## STAFF REPORT

**SPECIAL PERMIT AMENDMENT APPLICATION NO. SPA 81-A-002-05**

**APPLICANT/OWNER:** Pilgrim Community Church, Inc.

**SPECIAL PERMIT PROPOSAL:** Amend previously approved Special Permit for a church to permit site modifications (additional parking).

**SHEET 1 OF 4**  
 RP 2434

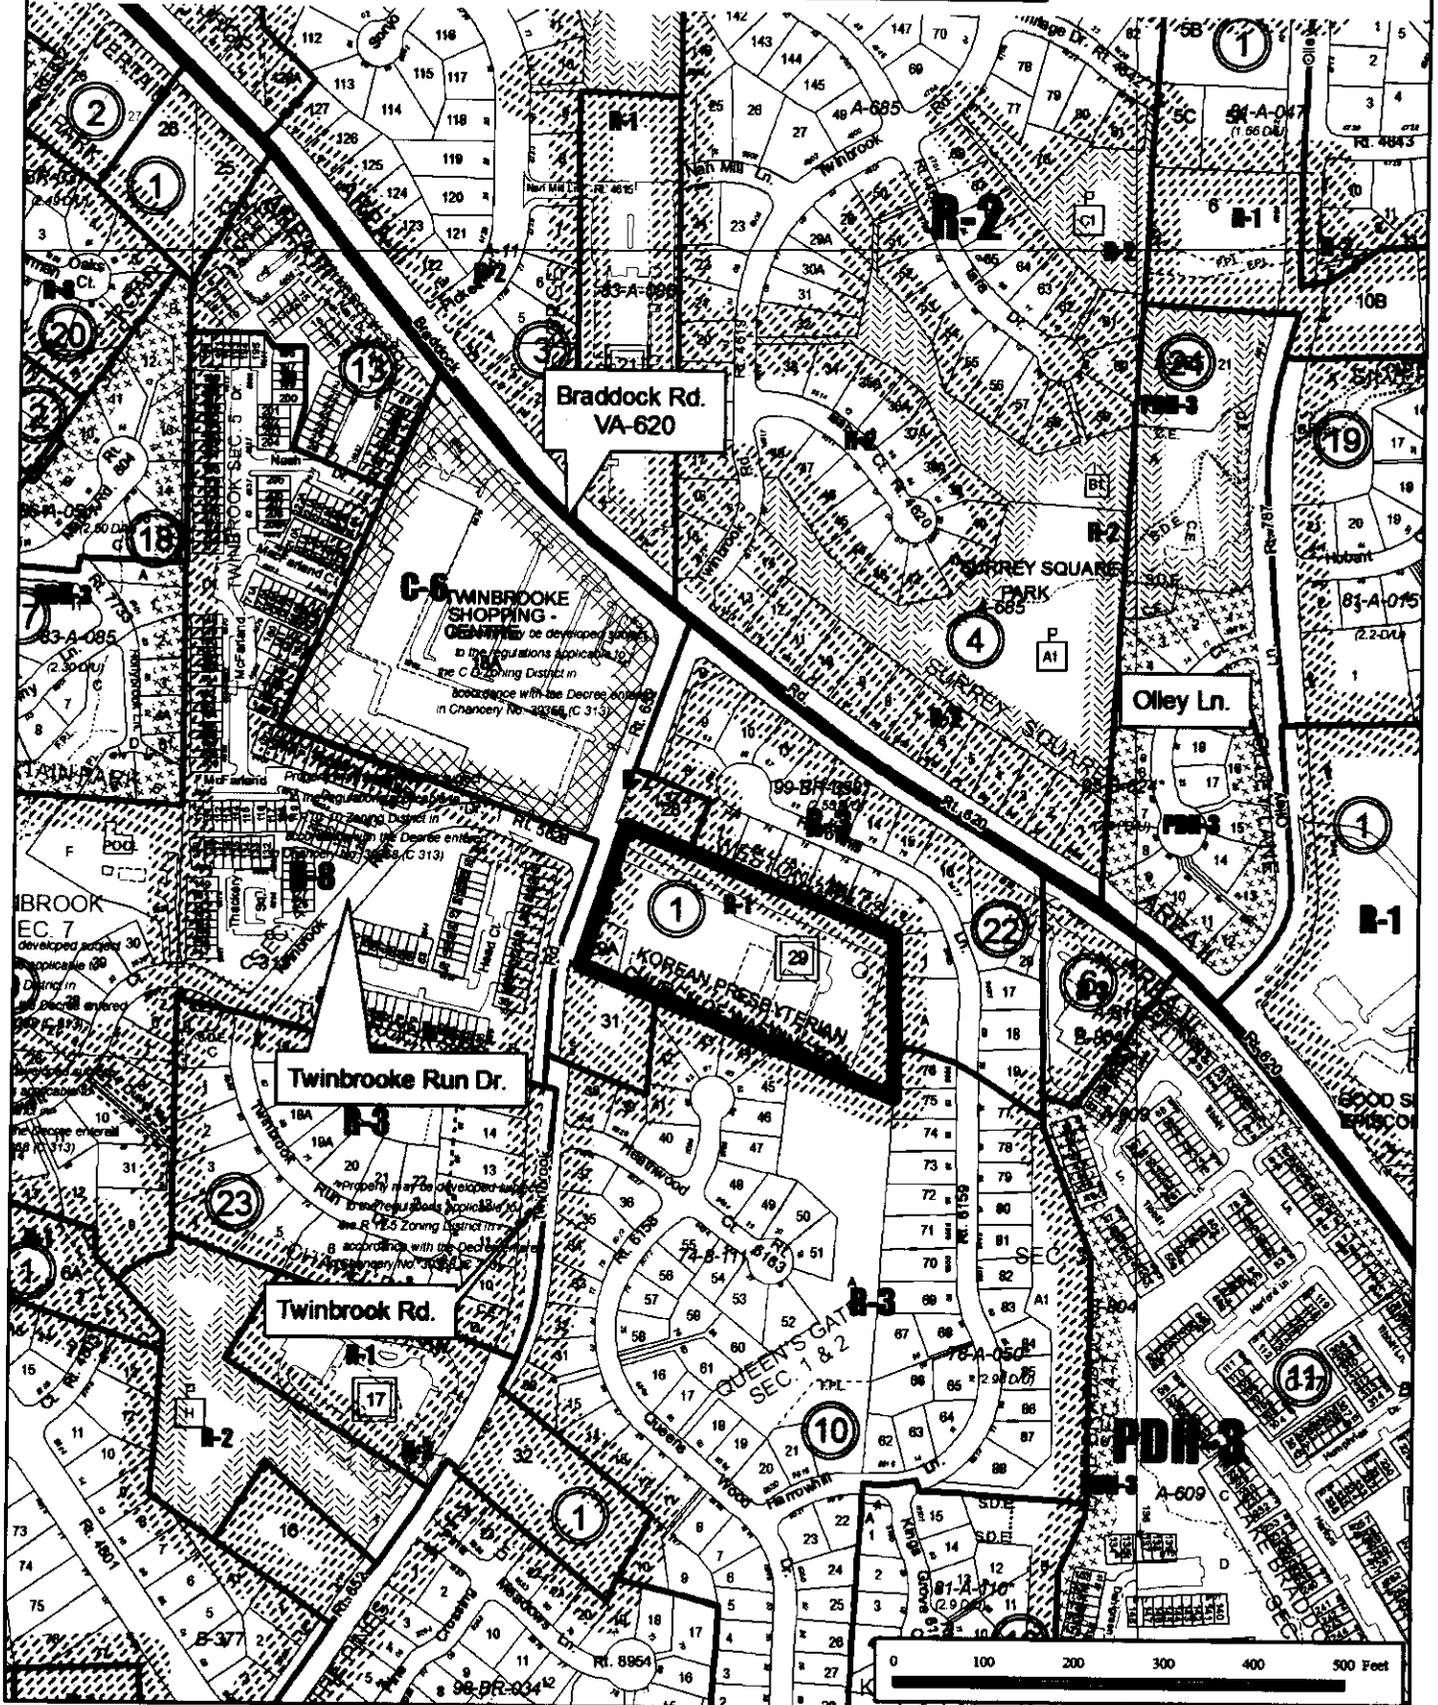
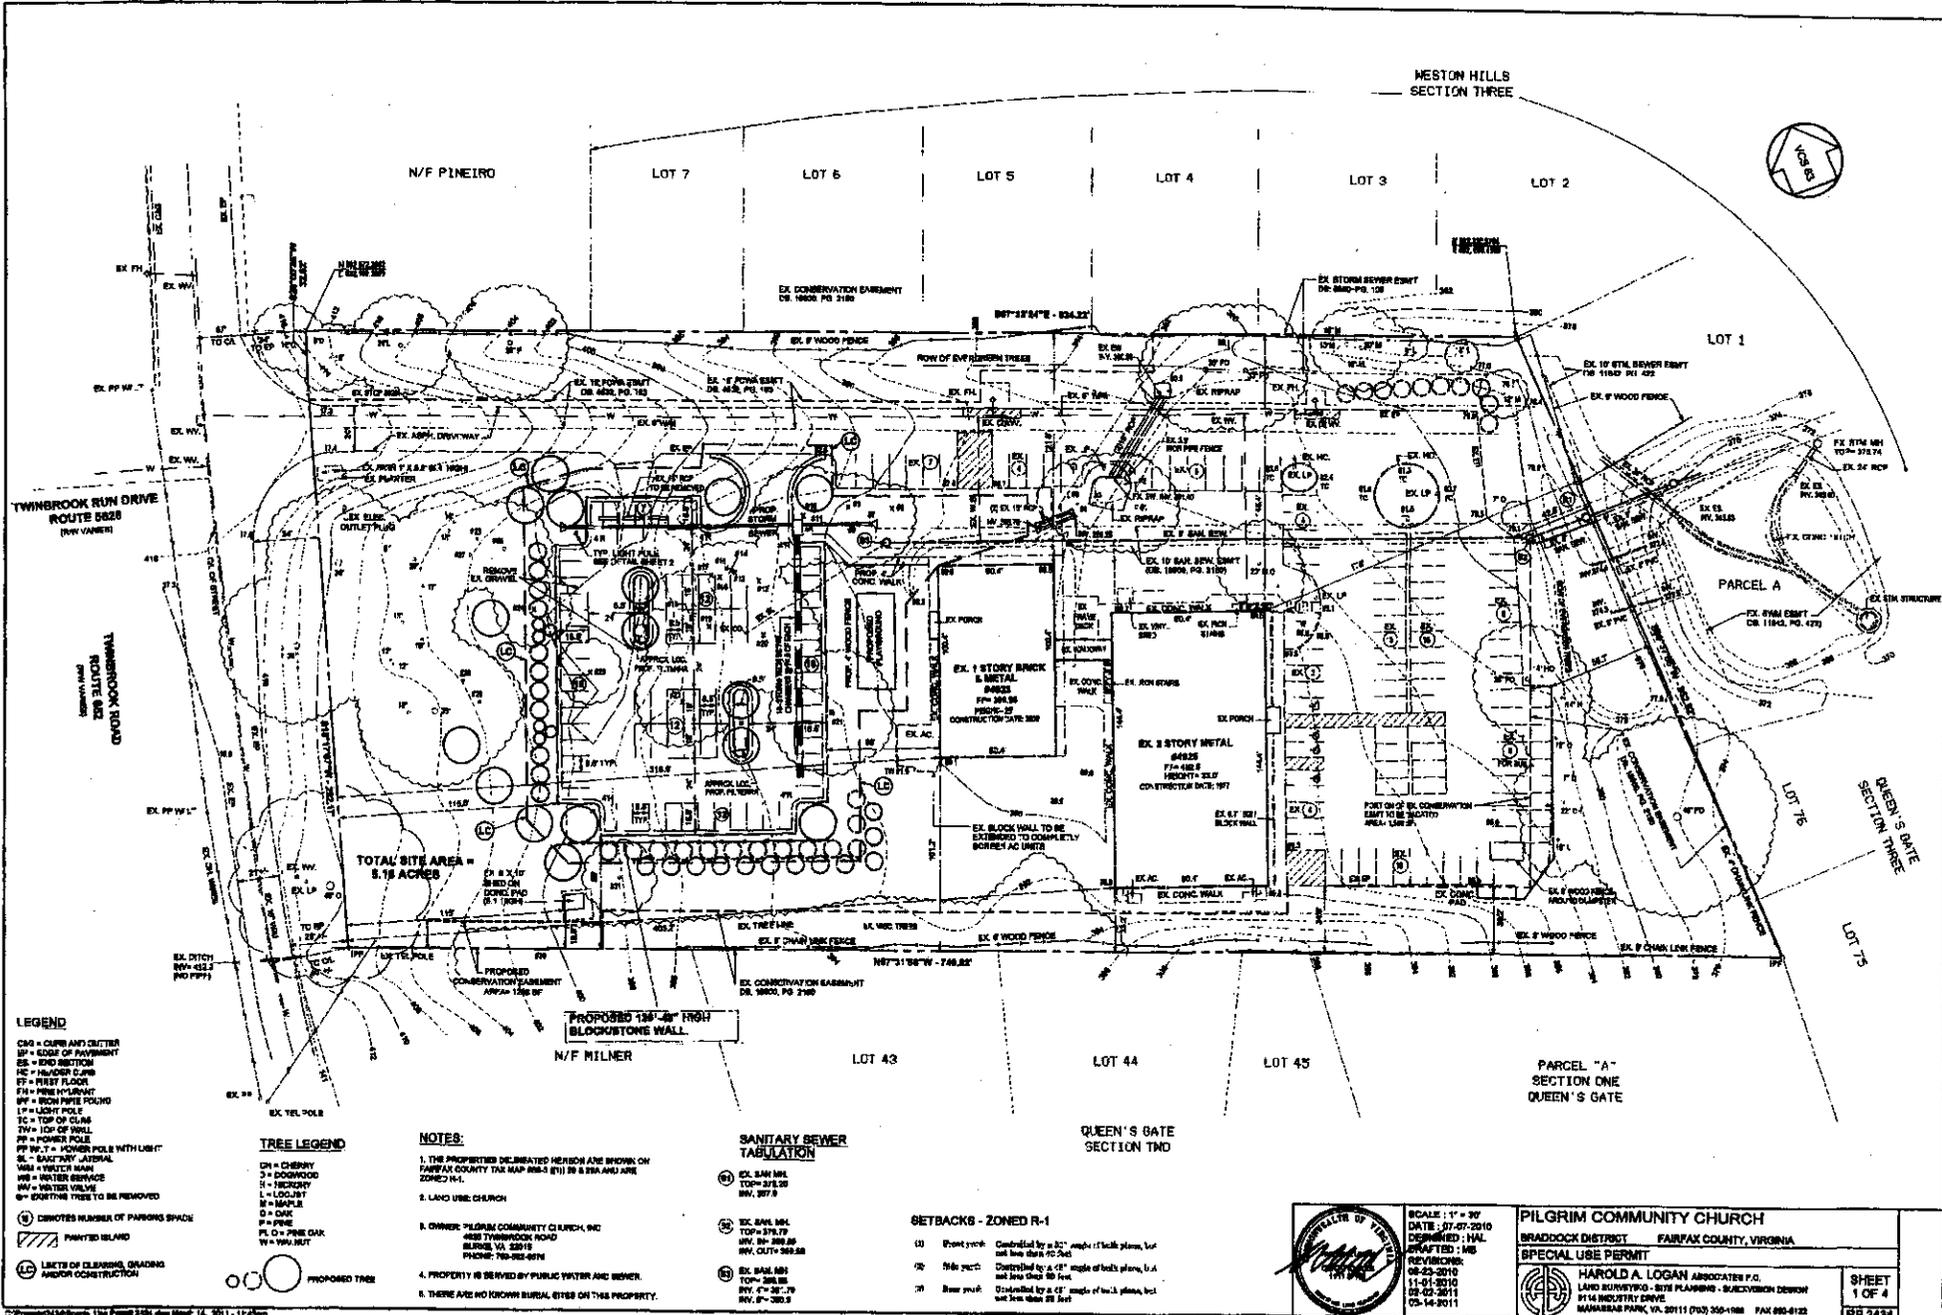
The in-situ soil infiltration test locations INF-1 and INF-2 need to be shown on the plat. The soil infiltration test show an average field infiltration rate of 1.3 inches per hour and half of this field average shall used for design per Letter to Industry #10-04. In addition, 4-ft separation between the invert of the StormTech chambers and the highest seasonal groundwater table is required.

2. **Comment:** The Existing Vegetation Map (EVM) provided does not appear in conformance with the required elements as detailed in PFM 12-0506. Not all existing woody vegetation that exceeds 5 feet in height at time of plan submission has been included and shown by their outer canopy edge. Many new trees were required and planted after the previous SP was approved; for example all the trees surrounding the new building. They are not shown on the plan nor included in this EVM. Therefore the tree canopy calculations are incorrect.

3. **Comment:** The tree inventory and condition analysis that has been submitted is not legible. Critical root zones of inventoried trees are not clearly shown and it is impossible to tell which trees are inventoried since corresponding tree numbers are illegible.

4. **Comment:** The “area to be counted” for interior parking lot landscaping calculations is unclear as no graphic showing the “area to be counted” has been submitted. It is also unclear which trees are counted towards meeting the interior parking lot landscaping requirements and therefore it is unclear if interior parking lot landscaping requirements have been met.

5. **Comment:** A multiplier of 1.5 for native trees has been taken for many of the proposed plantings. As mentioned in the previous comment it is unclear if interior parking lot landscaping requirements per ZO article 13 have been met. A multiplier may not be used in order to meet the basic ZO requirements of interior and peripheral parking lot landscaping or transitional screening.

6. **Comment:** A multiplier of 1.5 for native trees has been taken for many of the proposed plantings. It is unclear which trees received a “native” multiplier as some of the proposed plantings would not qualify for this multiplier.

7. **Comment:** It is unclear which trees are shown to be preserved and which trees will be removed.

8. **Comment:** Transitional screening 1 (25 feet wide) and barrier D, E or F are required along the northern, eastern and southern property boundaries. Transitional screening is not labeled and it is unclear if the transitional screening meets all requirements. A request to waive/modify the requirements in favor of existing vegetation accompanies this request. The modification request should include a detailed justification in conformance with ZO-13-305.

9. **Comment:** Many mature trees and several newly planted trees are proposed to be removed for the new parking lot. The Church has previously parked cars on a portion of the site under existing canopy where they had placed gravel as a temporary parking area. The former house driveway was used as an entrance for this parking area. The house has been removed and a large open area is present that should be considered as an alternative location for the parking lot.

**Recommendation:** Provide an EVM that depicts the location of any cover types identified in PFM Table 12.2 and one that provides the required elements as detailed in PFM 12-0506. The EVM should accurately depict the location of the outer edge of the tree canopy of individual trees and forested areas at time of plan submission. The EVM should identify the percentage of the development site covered by tree canopy comprised of self-supporting tree and woody plants that exceed 5-feet in height. The tree preservation target calculations should be up-dated accordingly.

**Recommendation:** A clear tree inventory and condition analysis in conformance with PFM 12-0507 should be submitted with the Special Permit Amendment request. All trees 12 inches or greater in diameter located within 25 feet of the proposed limits of clearing within the undisturbed area and within 10 feet of the limits of clearing in the disturbed area should be clearly shown by their critical root zone on the Tree Conservation Plans. (PFM 12-0507.1 and following and 12-0507.2 and following)

**Recommendation:** Applicant should provide interior parking lot landscaping calculations and a graphic to show that interior parking lot landscaping requirements will be met. Trees used to meet the interior parking lot landscaping requirements should be clearly indicated on the plan.

**Recommendation:** Applicant should provide interior parking lot landscaping that meets the requirements of ZO article 13 without using a multiplier.

**Recommendation:** Applicant should provide a plant schedule that clearly indicates which trees received a “native” multiplier.

**Recommendation:** All existing vegetation that is proposed to provide 10-year canopy credits shall be shaded and labeled with their square footage on the plans to indicate the

**Recommendation:** Applicant should provide transitional screening and barriers in conformance with present ZO requirements. All transitional screening yards should be labeled. Existing vegetation appears to meet the intent of the ZO in some but not all locations. Additional plantings should be required along the northern and southwestern boundaries to meet the intent of transitional screening. A motion to allow existing vegetation to serve as transitional screening with the addition of trees along the northern and southwestern boundaries should be brought before the Board
